Consultant	Wahib Medanat Consultant Engineer	Rep No.	11-27072021
Contractor	Derar Saraireh & Sons for Engineering & Contracting	Tender No.	(11/2019/USAID/SKEP/3/S) Schools for a Knowledge Economy Project (SKEP) - Phase (3) Package (1, 2)
Site Name	Um Al Dananir Basic Mixed School- Al Balqa	Day/ Date	Tue. 27/07/2021
Duration of Project	450 Calendar Days	Total Project Budget	9,789,417.840 JD

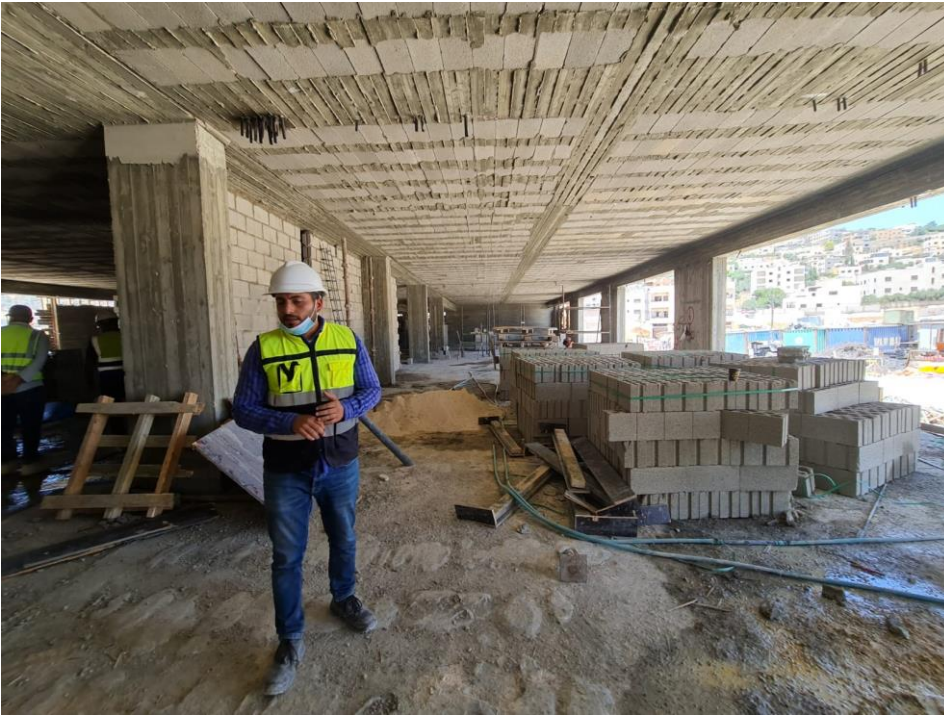
Voids within block walls were noticed and the Contractor was instructed to close them correctly

Block walls are not in line with the columns in some places, this issue will be resolved during plastering work
